Report of Dam Safety Assessment of Coal
Combustion Surface Impoundments
NRG Energy
Huntley Generating Station
Tonawanda, NY

AMEC Project No. 3-2106-0194

March 2013

NRG Embankment Evaluation, Static Condition @ South Ash Settling Basin

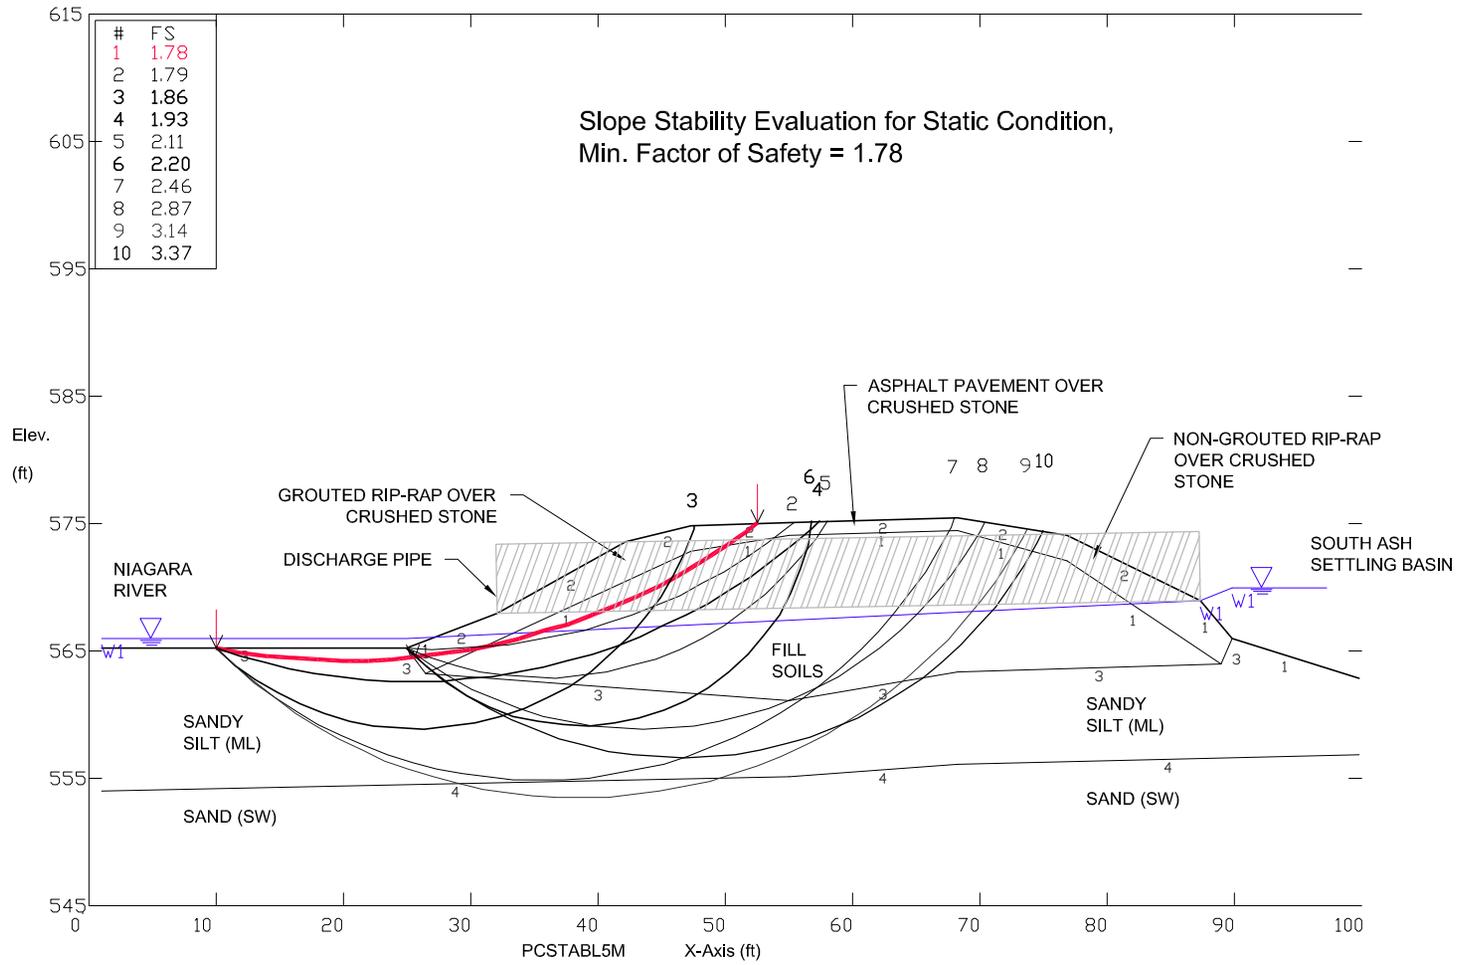
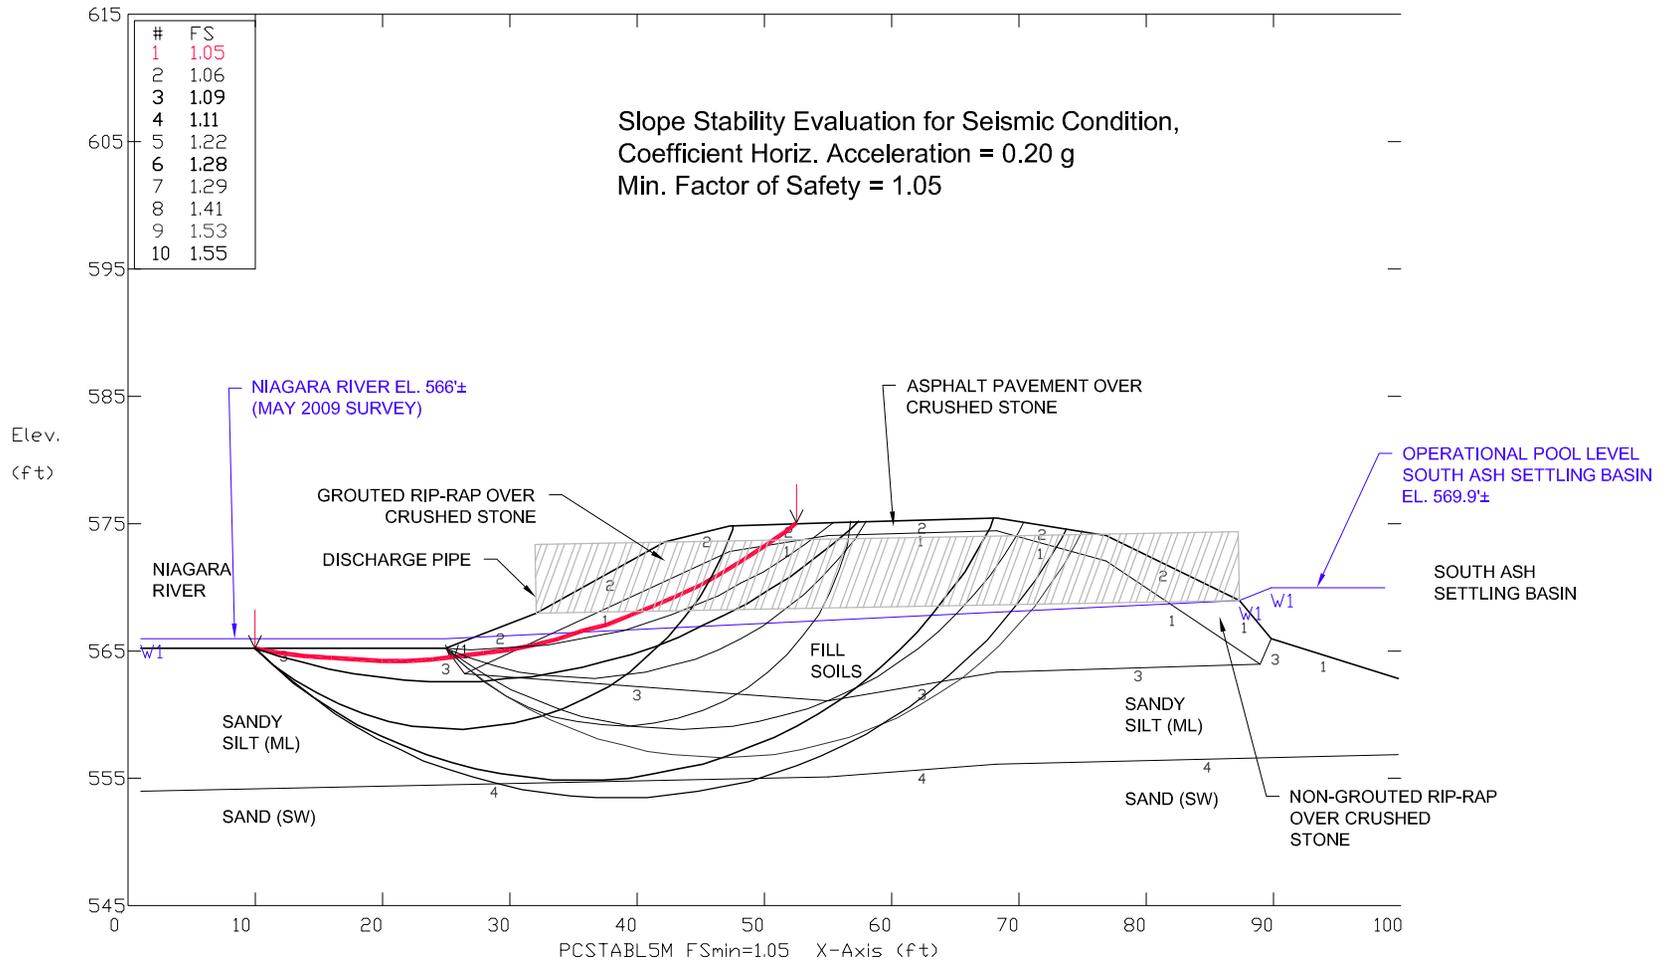
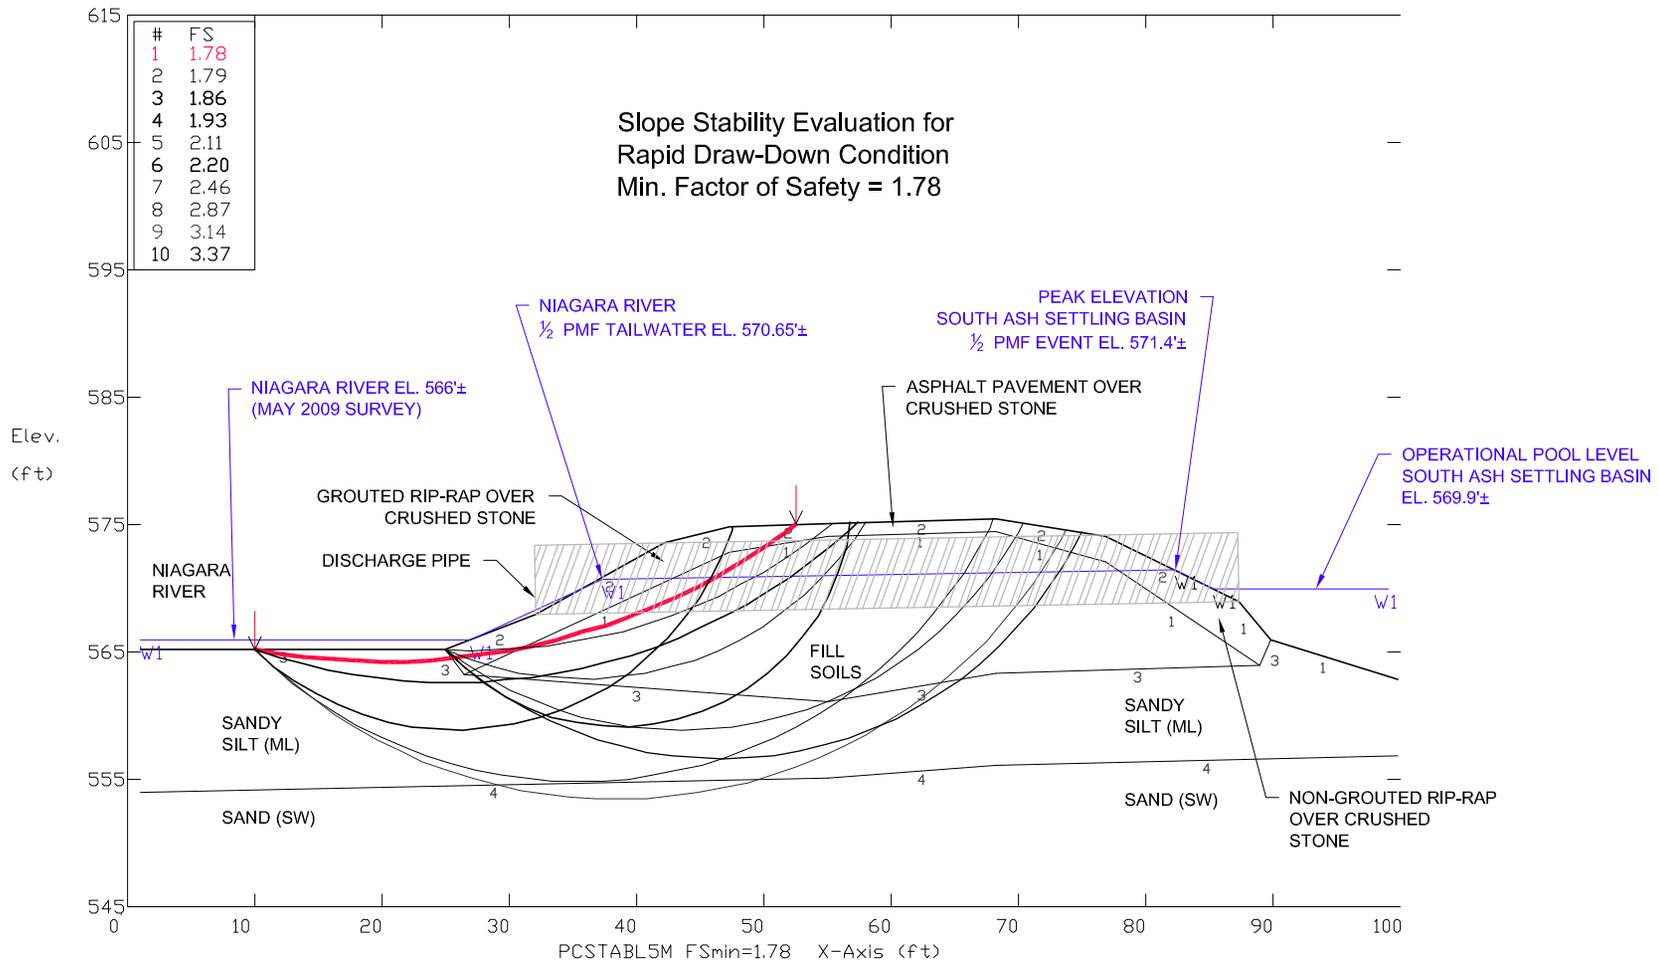
Discussion in the letter response on the analyses for the South Ash Pond provides justification for the friction angle of 30 degrees for the fill based on typical published values for the soil type. GZA also states “Due to the presence of gravel, slag, concrete, brick, cobbles and wood debris in the fill soils, plus the presence of the 65” x 92” steel arch pipe providing reinforcement, it is GZA’s opinion that the debris and pipe gives greater interlocking and a higher shear strength that warranted assigning a mid-range friction angle of 30 degrees to the fill layer.” GZA also notes “the critical failure surface, shown on the attached stability analyses, occurs at a shallow depth where denser soils exist. Less critical failure surfaces, having higher factors of safety, occur at greater depth through the loose fill soils.” For the seismic analysis, GZA applied a maximum horizontal acceleration (MHA) of 0.2g (90 percent probability of not being exceeded in 250 years), based on “Probabilistic Earthquake Acceleration and Velocity Maps for the United States and Puerto Rico”, U.S. Geologic Survey, Map MF-2120. This is a conservative value based on published information. More recent published data, which has catalogued earthquake activity, indicates lower MHA values.
